CONNECTICUT YANKEE ATOMIC POWER COMPANY

HADDAM NECK PLANT

Haddam Neck Plant
Request for Modification to Exemption for the
Shipment of Reactor Vessel

ENCLOSURE 2
ADDENDUM
TO
TRANSPORT SYSTEM DESCRIPTION REPORT
(TSDR)
HADDAM NECK PLANT
REACTOR PRESSURE VESSEL

ADDENDUM FIGURE 1

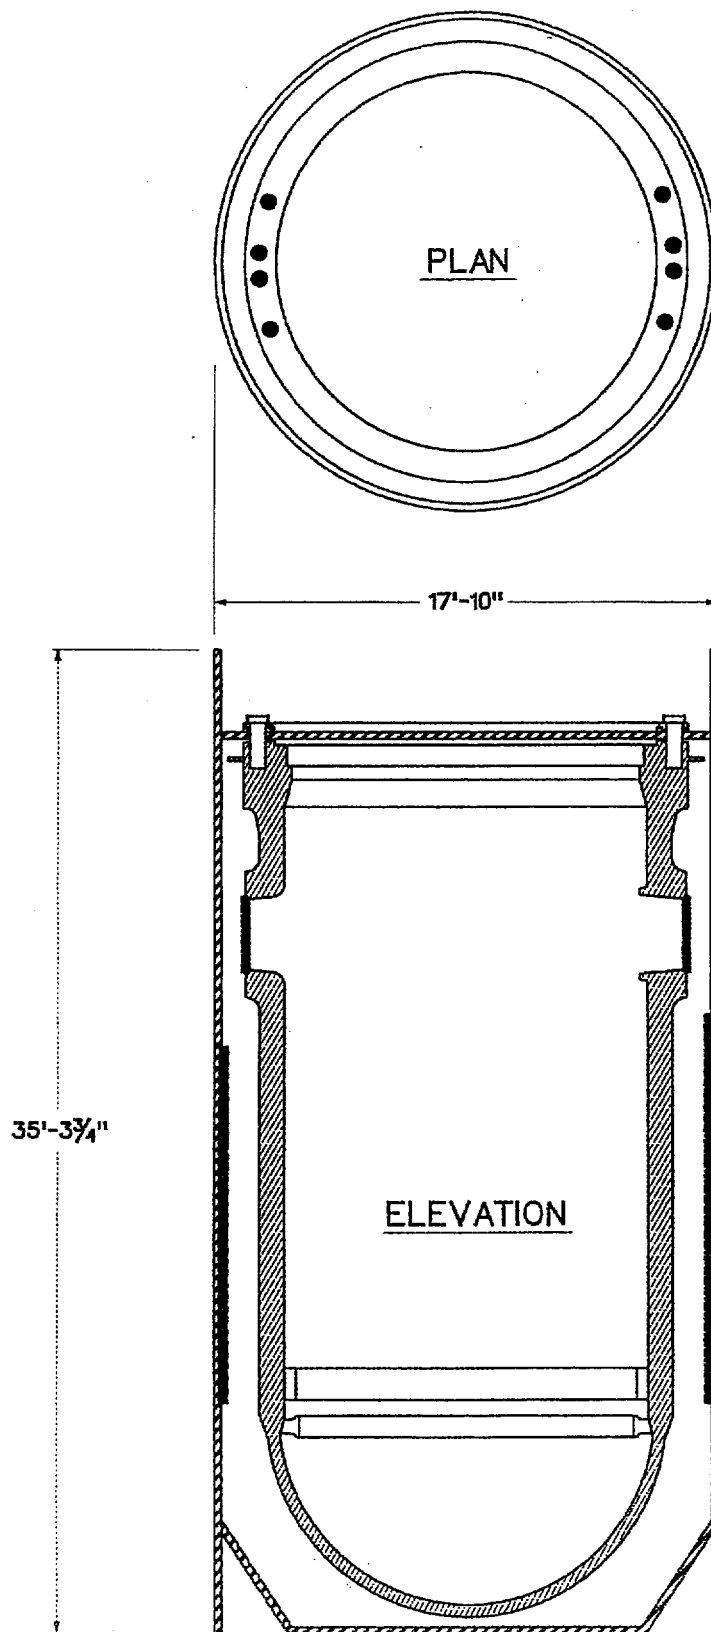
<p>1.2.3: Package</p>	<p>With the identified absence of closure head, vessel nozzles, and vessel insulation, the weight of the canister with its contents, including grout, is about 700 tons (Supplemental Reference #1, Bechtel Engineering Judgement Document 24265-200-30V-C12K-00012-000), rather than about 800 tons as previously reported.</p> <p>In the reconfigured RPV package, RPV closure studs are not used to attach the RPV to the canister. Rather, the position of the RPV in the canister is maintained by: (i) the nominal 70 lb/ft³ low density cellular concrete (LDCC) in the bottom and annular regions of the canister and (ii) a six inch layer of nominal 120 lb/ft³ structural grout at the top of the canister. The structural grout within the top of the canister also supports on-site rigging operations.</p> <p>On-site rigging operations include the use of eight rigging studs that pass through penetrations in the canister top plate and fasten to the upper flange of the RPV. Following the transfer of the loaded canister to the cradle of the RVTS, each of these eight rigging studs will be disabled by: (a) cutting off the stud flush with the shear ring attached to the top plate and (b) welding a three (3) inch thick carbon steel cap over the corresponding penetration in the top plate/shear ring. Each of the welded steel caps provides a metallic seal between radioactive contents and the environs.</p> <p>For each of the other canister top plate penetrations (corresponding to the previously planned attachment of the closure head), a steel plug or cover plate with a thickness of at least 3 inches will be welded into or directly over the penetration. Each of the welded steel plugs or cover plates provides a seal between the radioactive contents and the environs.</p> <p>With the application of these sealing devices, the reconfigured RVTS does not require and, consequently, does not include application of spray metalizing as a sealant.</p>

TSDR Section	Comments Concerning Reconfigured RVTS
Figure 1-4: "HNP Package Shipping Configuration"	Addendum Figure 1 displays the reconfigured Package Shipping Configuration.

ADDENDUM FIGURE 2

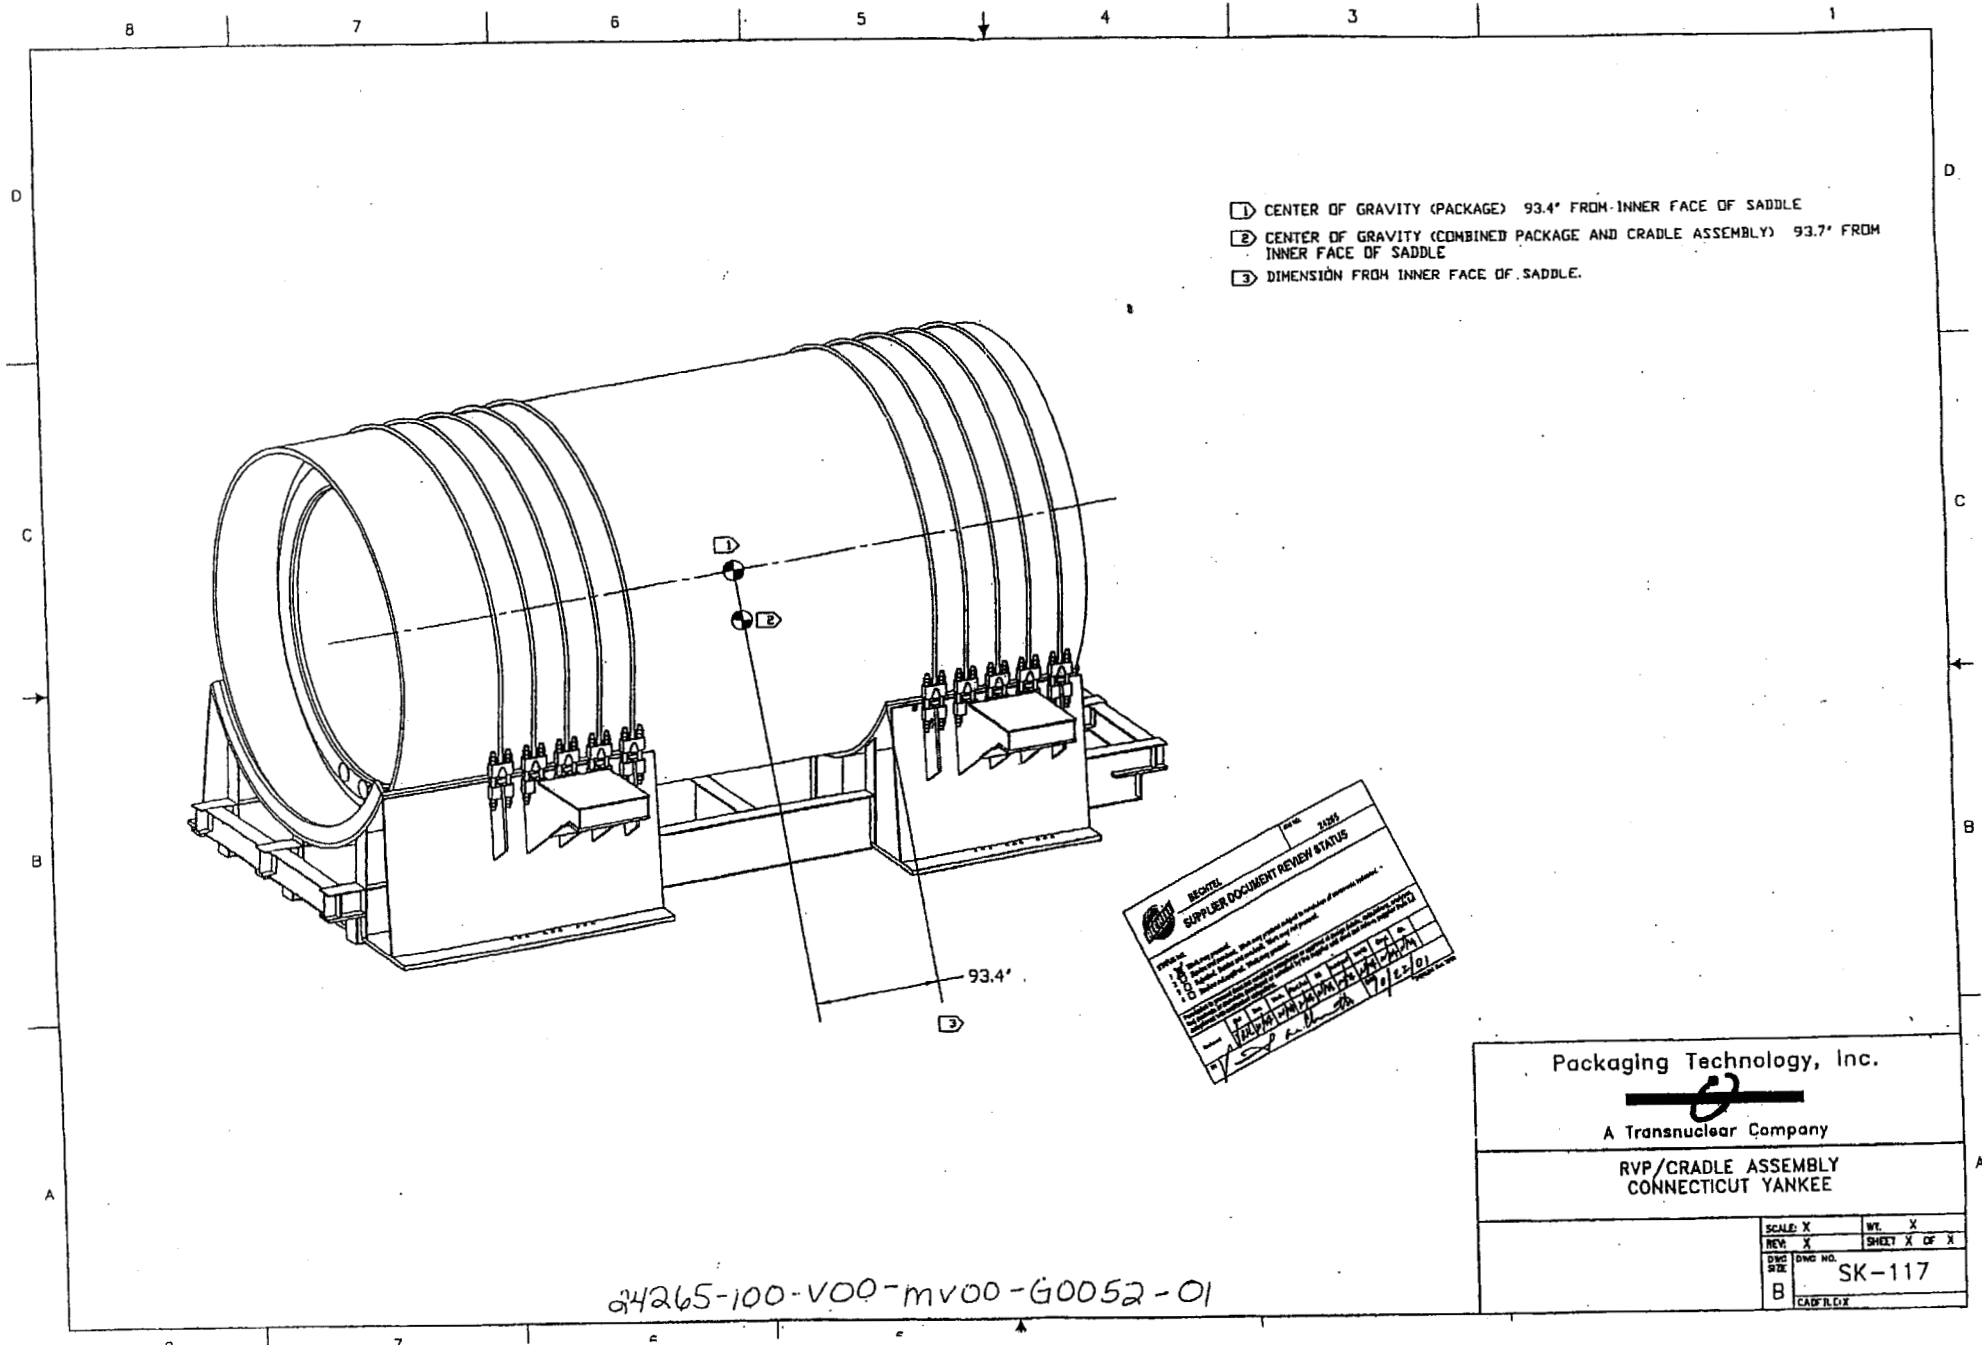
2.5: Tie-down System	With the identified absence of closure head, vessel nozzles, and vessel insulation, the center of gravity of the loaded canister of the RVTS is different from the previously planned configuration. In order to more evenly distribute the footprint loads of the cradle, the canister is reversed in the RVTS cradle. An evaluation of the relevance of previous analysis to the reconfigured RVTS is provided by Supplemental Reference #1, Bechtel Engineering Judgement Document 24265-200-30V-C12K-00012-000.

2.5.1: Tie-down System Design Criteria and Analysis Results	Supplemental Reference #1 concludes that the previously referenced analyses for the tie-down system and the cradle are valid for the reconfigured RVTS.
Figure 2-1: "Tie-Down System"	Addendum Figure 2 displays the reconfigured tie-down system configuration.

ADDENDUM FIGURE 3

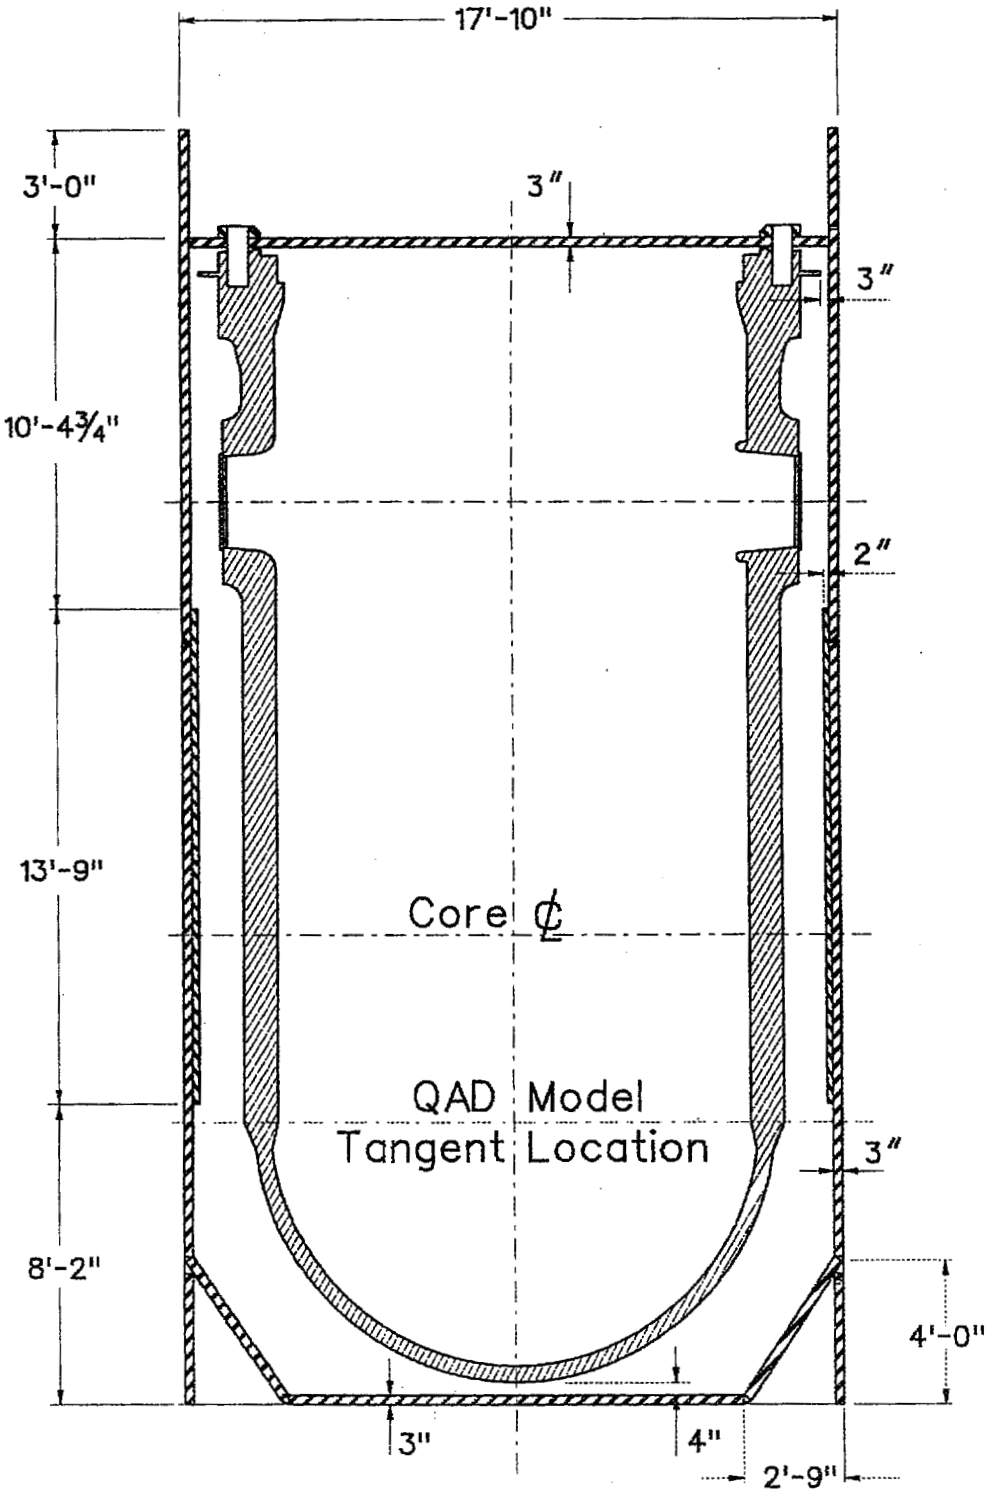
4.3.1: Shielding Configuration & Figure 4-3 "HNP Reactor Vessel Package Shielding Configuration"	<p>Addendum Figure 3, corresponding to Figure 4-3 of the TSDR report, shows the shielding configuration of the canister. As stated in Supplemental Reference #2, the analytical shielding model is consistent with the absence of the reactor vessel head from the exterior of the canister.</p> <p>Additionally, the closure devices for the top penetrations of the canister are consistent with the shielding contribution provided by the canister top plate.</p>
